RFP 25-05 – Transfer Center Renovation Contracting

Addenda 3

ADDENDUM 3
Mountain Line Transfer Station Remodel
Plumbing - Mechanical – Electrical

Date: 11/03/2025

P002

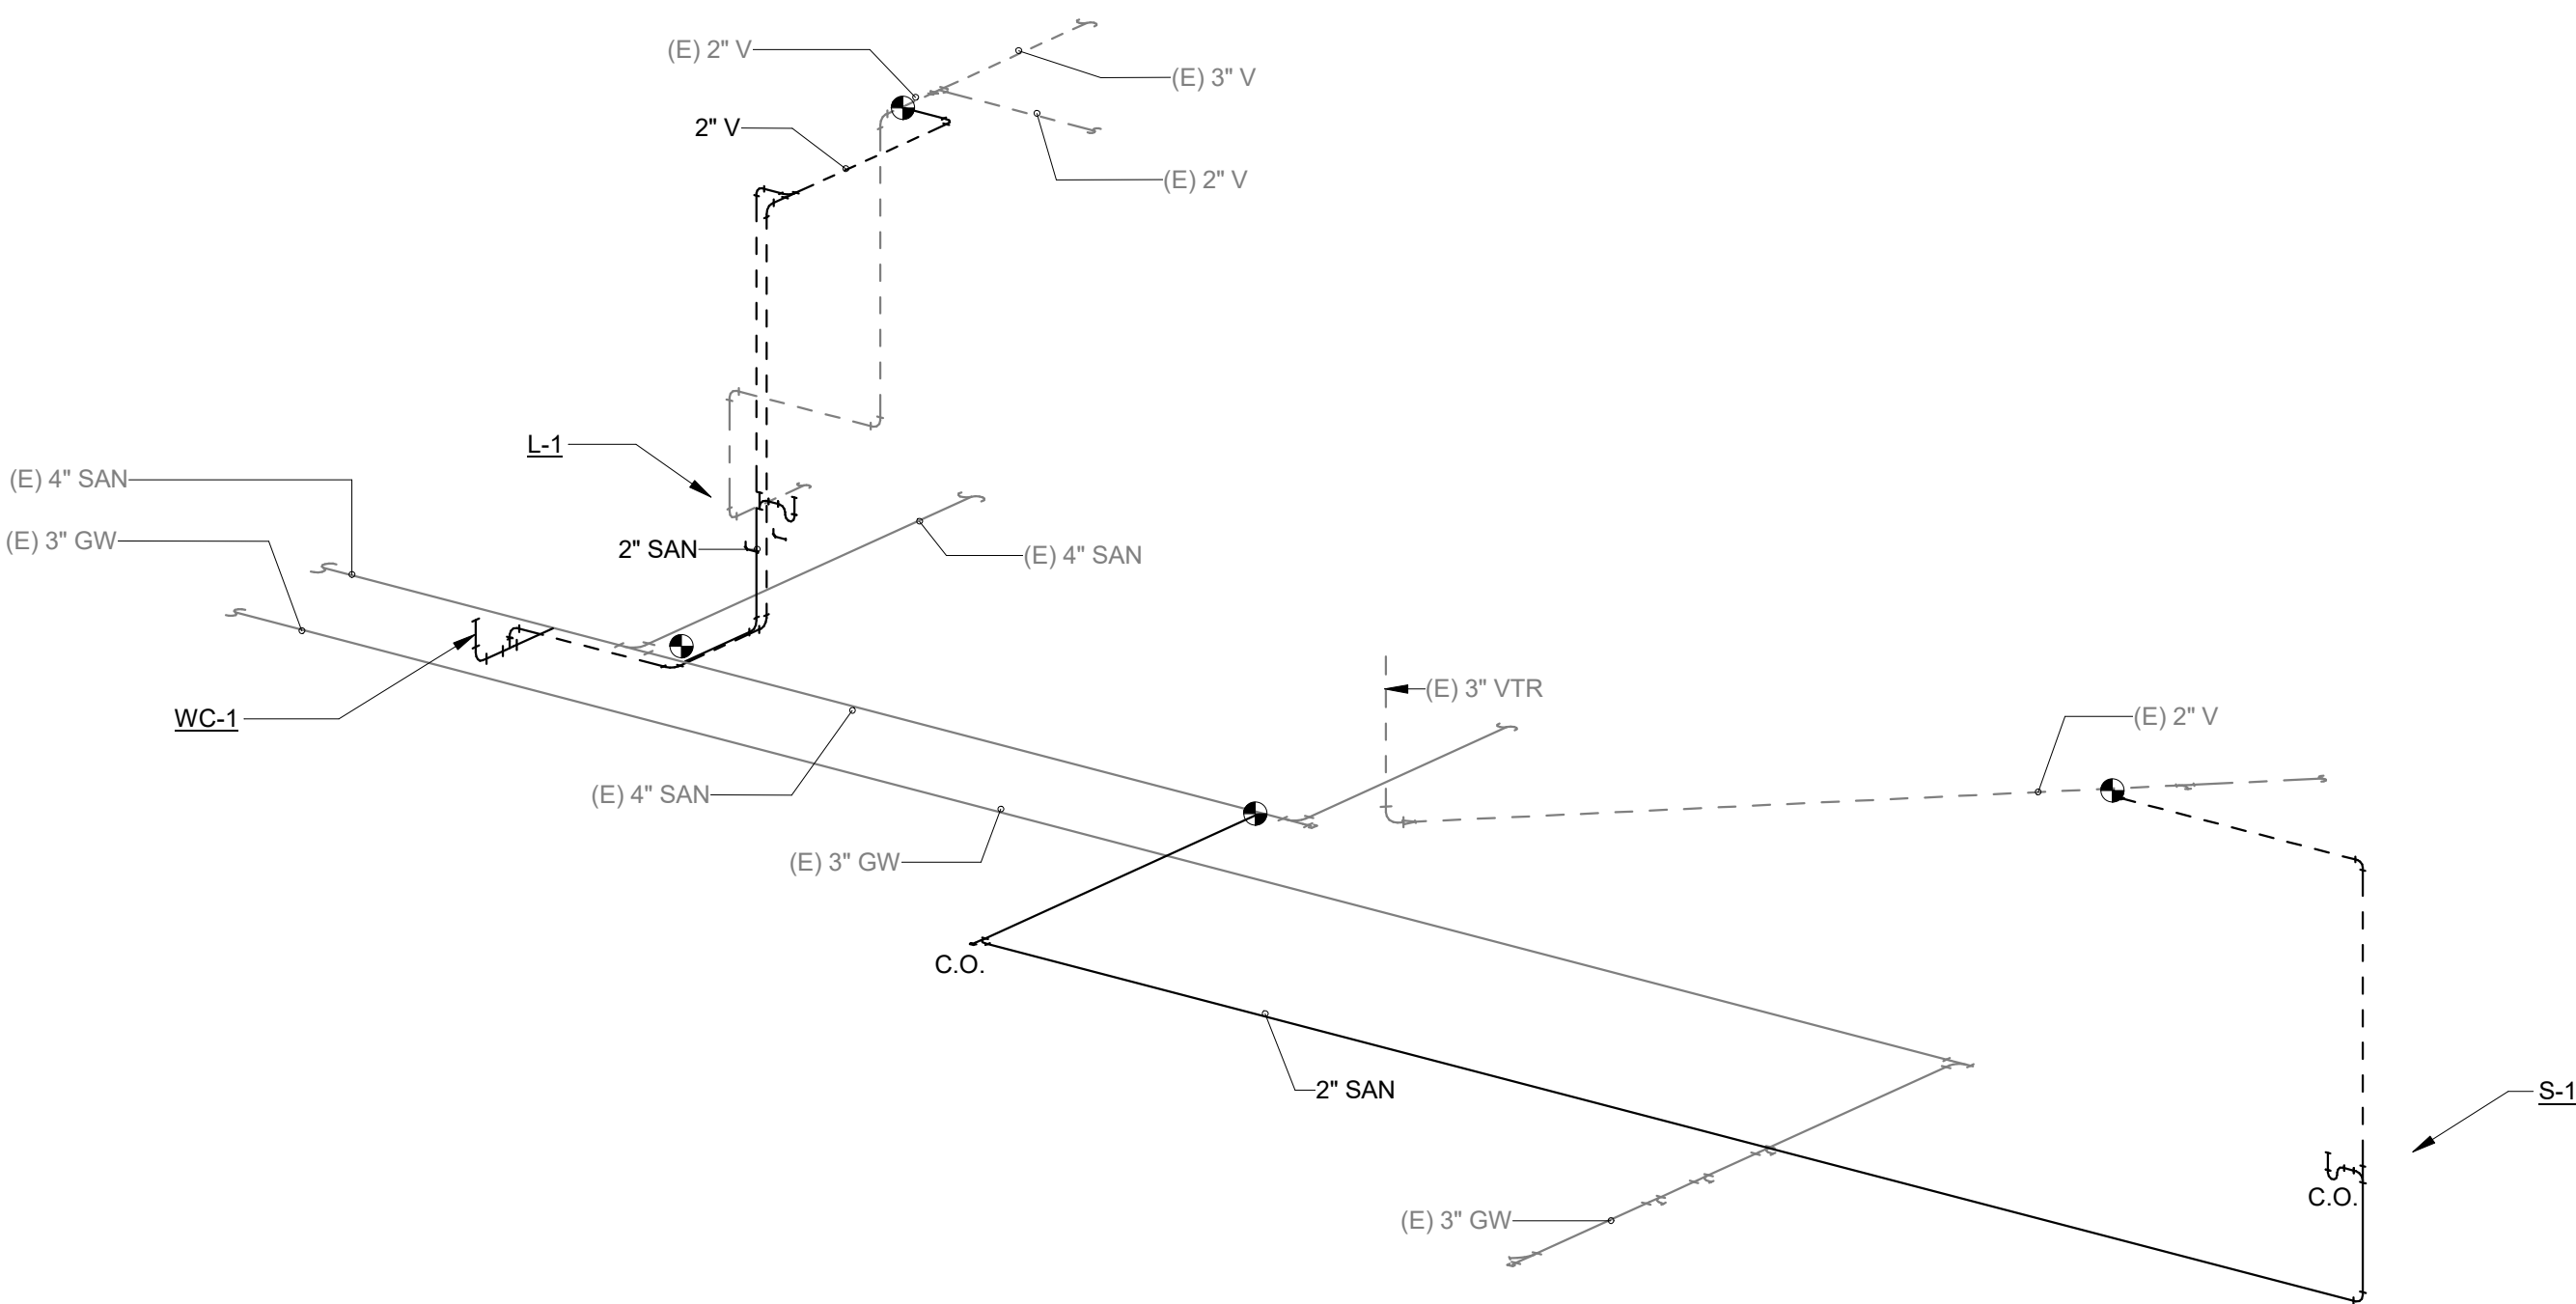
P002: Lavatory L-1 added to plumbing fixture schedule.

P101

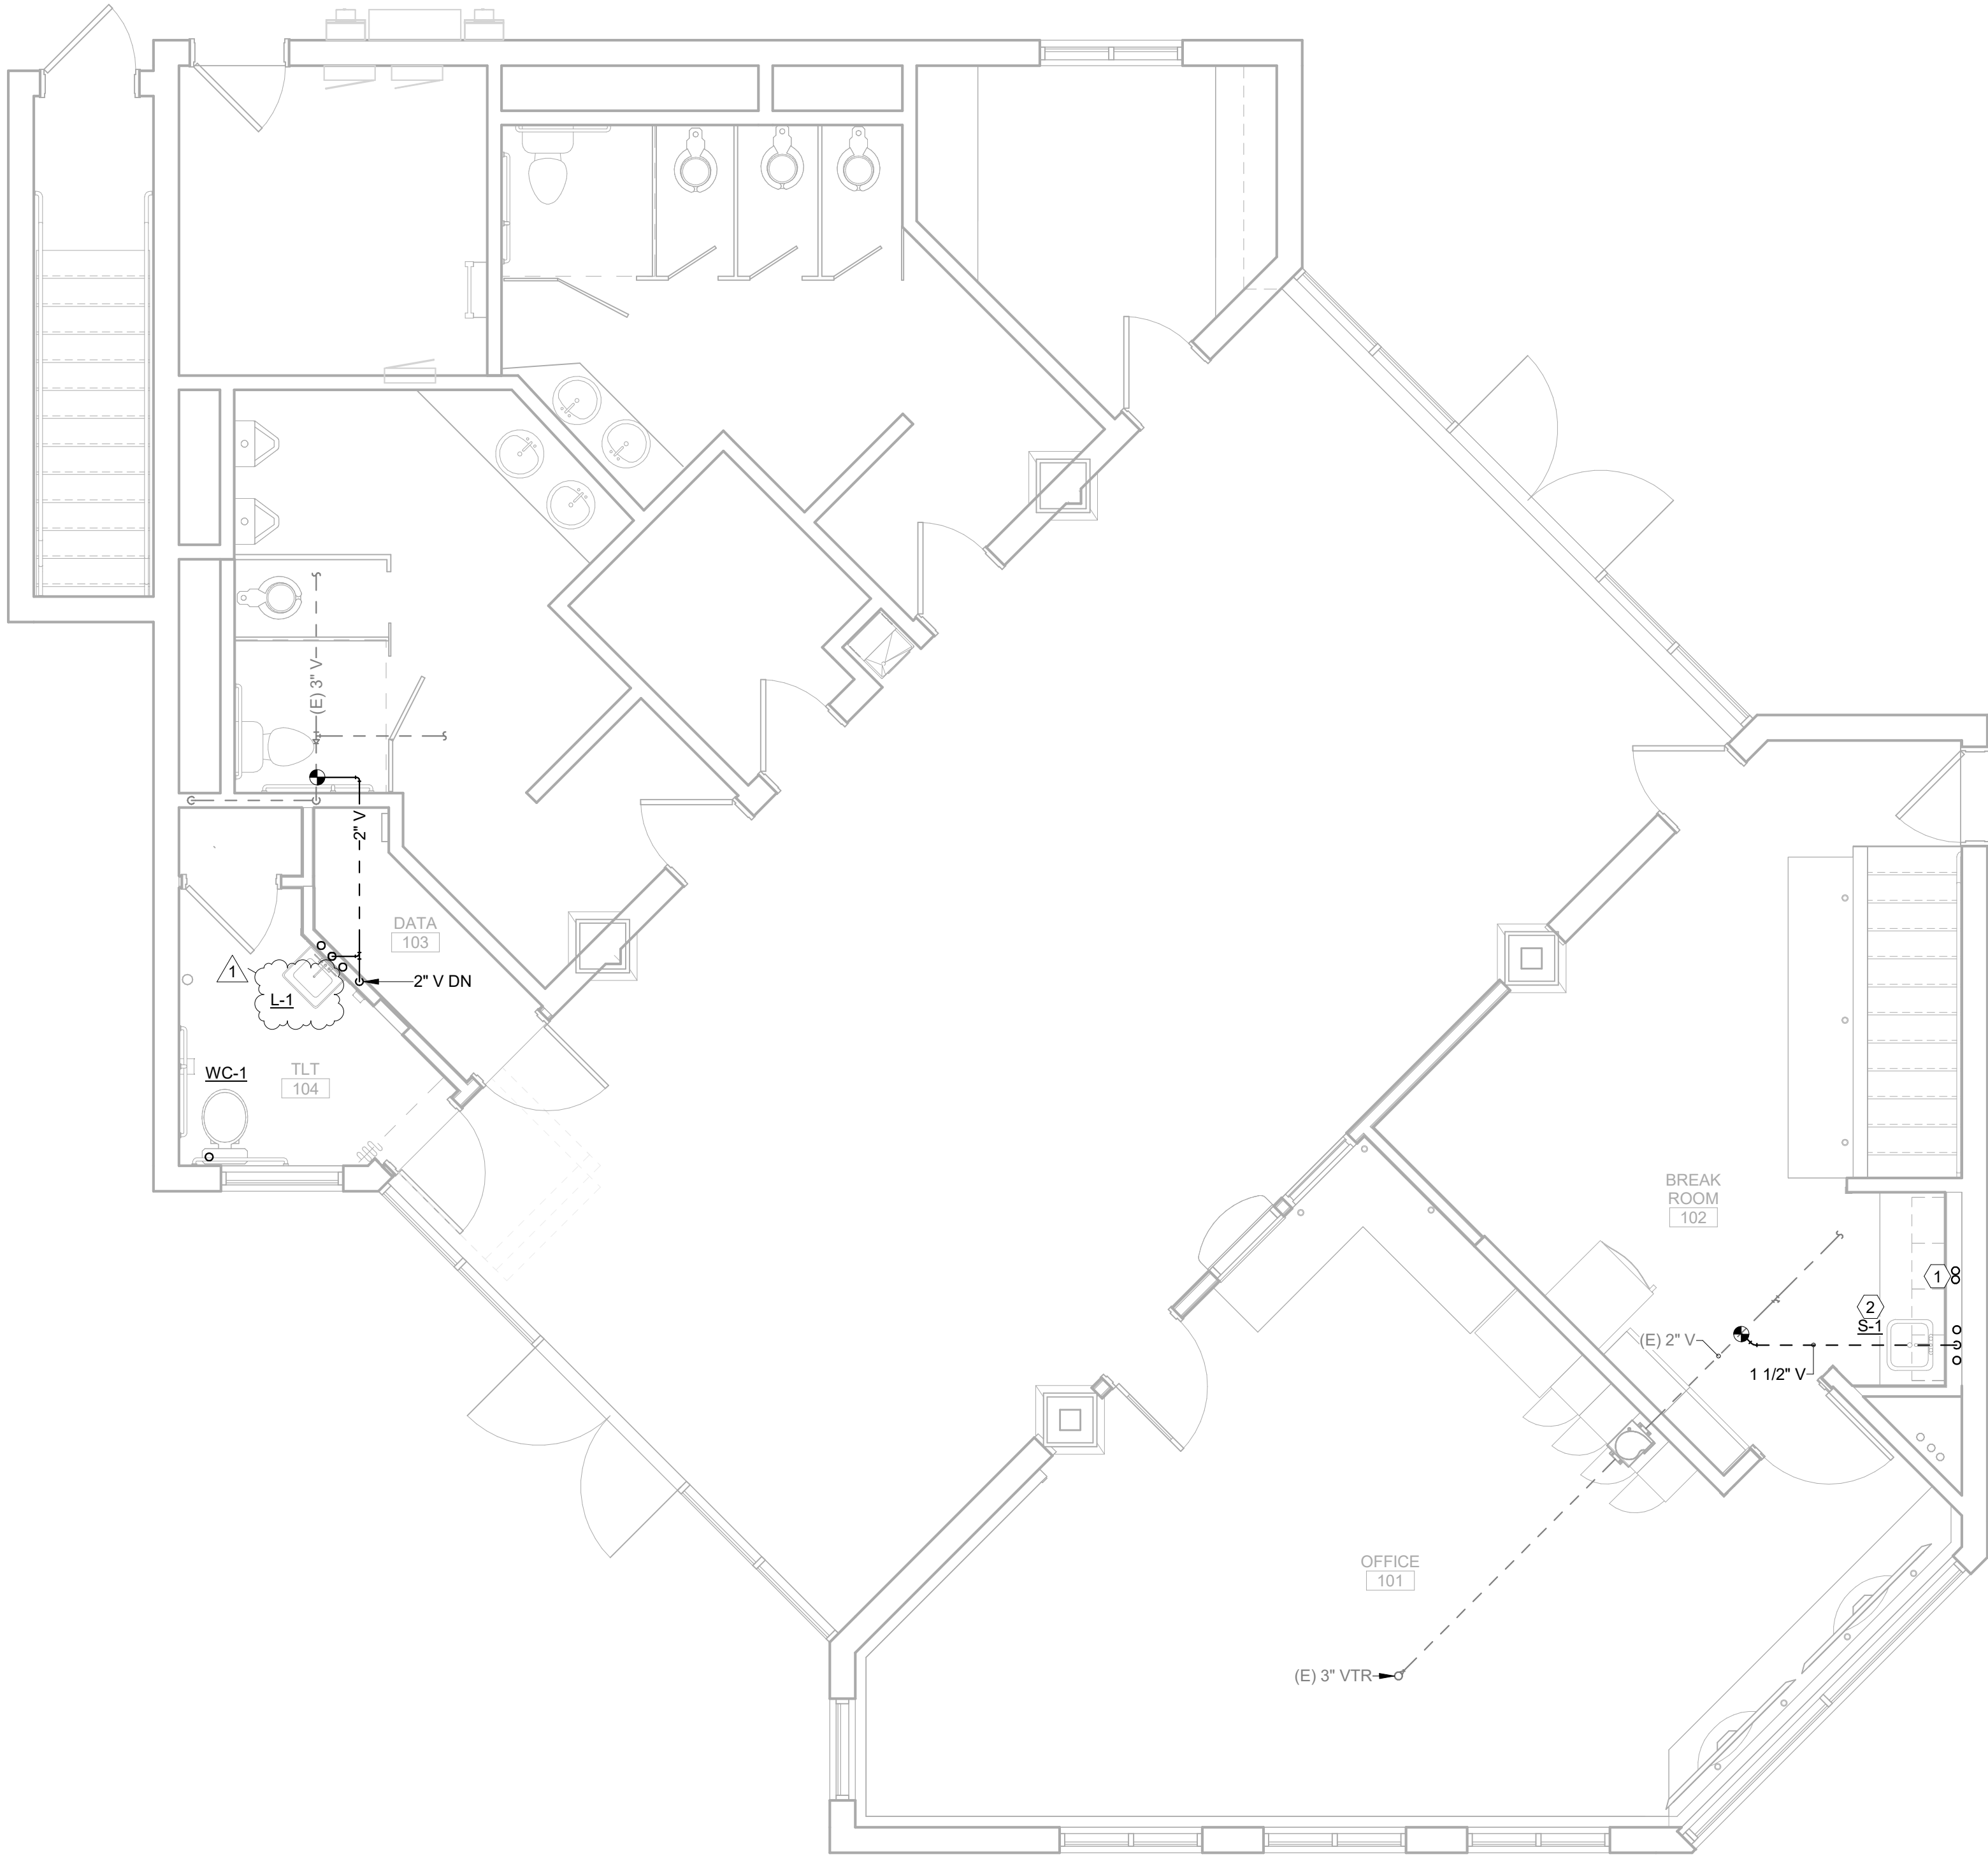
P101: Lavatory tag L-1 added to lavatory in TLT 104.
